The ALSEP Data Subsystem has been evaluated by an independent contractor to provide added confidence that no allowable sequence of commands can prevent proper operation of the ALSEP System. This report assesses the significance of the failure modes disclosed in this study.

Prepared by: R. Fatka  
R. Fatka, Command Decoder  
Project Engineer

Evaluation of Data Subsystem Failure Modes

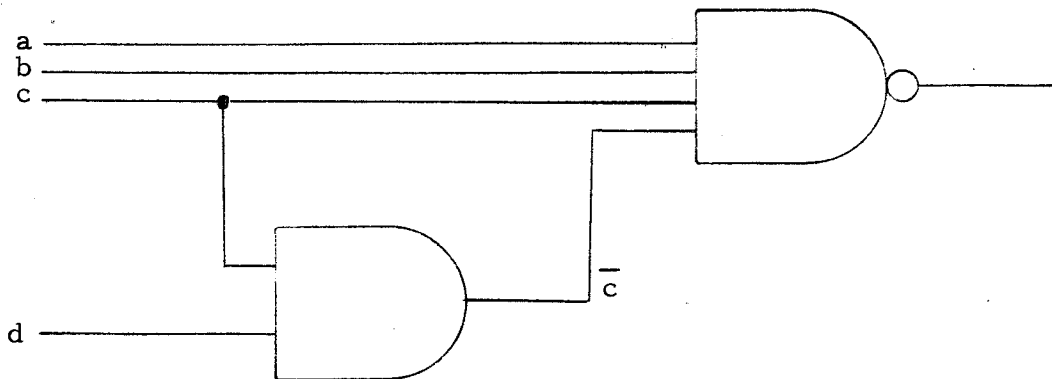
Situation (b). Manual Switching of PCU. - Commands 48 and 50 direct either section of the PCU to be used. Directing the second section be used by command 50 could disable ALSEP if the second PCU section were unknowingly inoperative.

Discussion. The philosophy behind the PCU design was to eliminate single points of failure. The automatic switch-over circuit will cause power conditioner (PC) 1 to turn off and PC2 to turn-on in the event of an over-or-under voltage condition. The automatic switch-over circuit will not switch back to PC1 in the event of an over-or-under voltage. This is to prevent oscillation between PC1 and PC2 in the event of any one of six failures in the switch over circuit.

There is no way to determine if PC2 is operational while PC1 is operating or vice versa. The non-operating PC is a redundant circuit which is inactive when the other PC is operating. Therefore it is very important that commands 48 and 50 be used only if the operating PC gives indications of impending failure and/or the automatic switch over circuit does not switch when an over-or-under voltage condition exists. The latter condition could only occur if the regulator in PC1 and the switch over circuit failed.
